RE: REVISED LAYOUT AND TURBINE SPECIFICATIONS FOR THE ZONNEQUA WIND FARM: HERITAGE OPINION

<u>FACILITY NAME</u>	<u>SAHRA CASE NUMBER</u>	<u>DEA REFERENCE NUMBER</u>
ZONNEQUA WIND FARM:	13065	14/12/16/3/3/1/1970

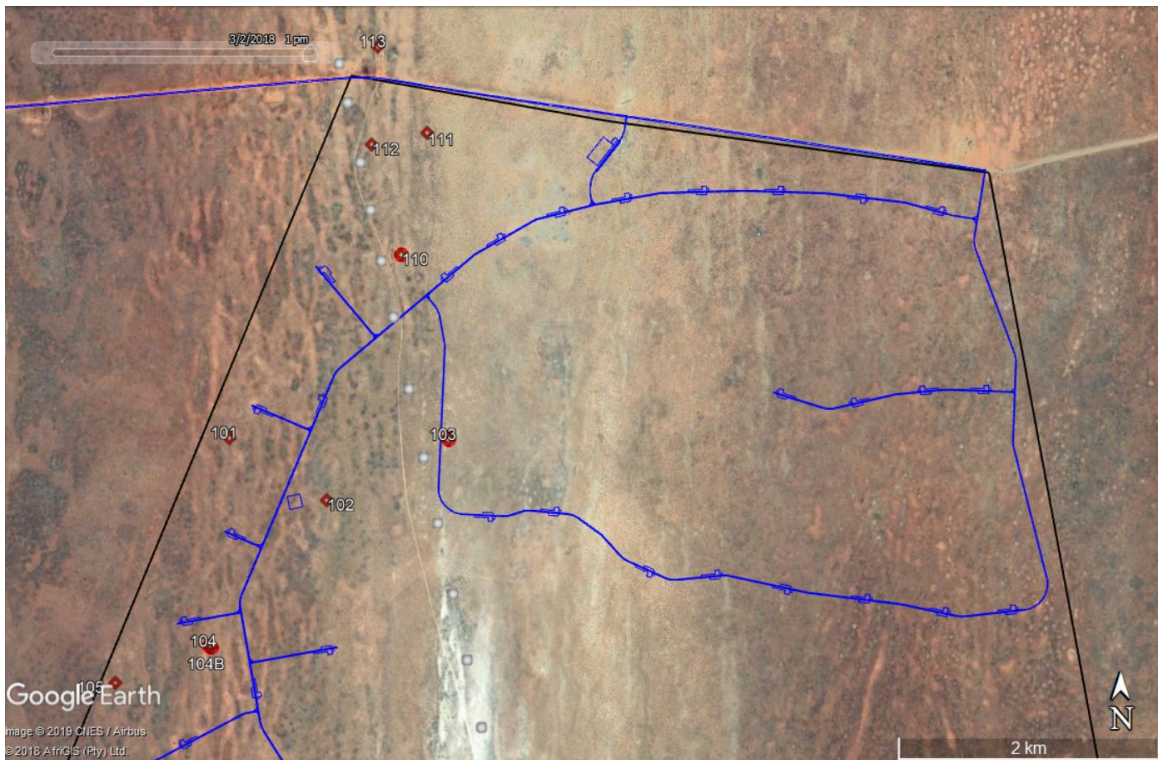
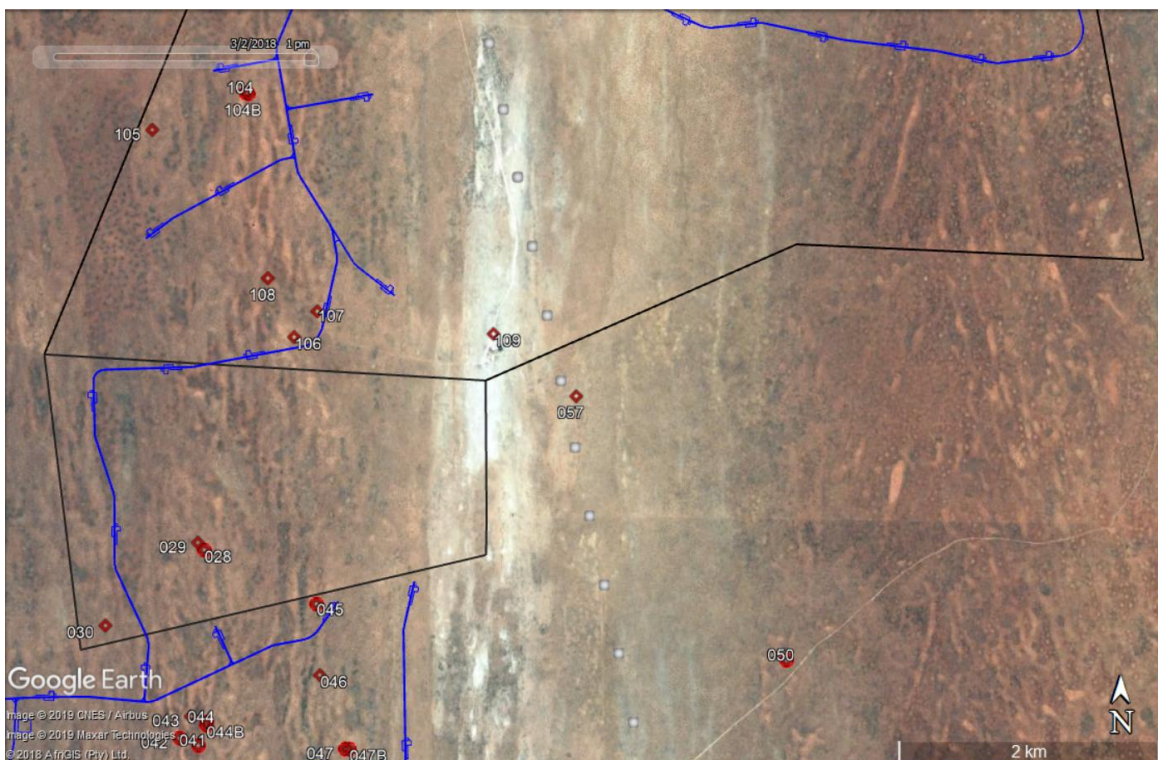
should be noted that some sites were found in the eastern dune cordon further to the south of the proposed layout. The amended layout has been devised to avoid all known sites but, although the survey carried out during the EIA aimed to locate as many sites within the study area as possible, it is still possible, indeed likely, that some sites will be intersected. The number, however, should be small. The HIA recommended that a walk down survey should be done pre-construction and this is still recommended for the amended layout.

- An archaeologist should be appointed to conduct a final pre-construction survey of the approved layout at least 6 months prior to commencement of construction;
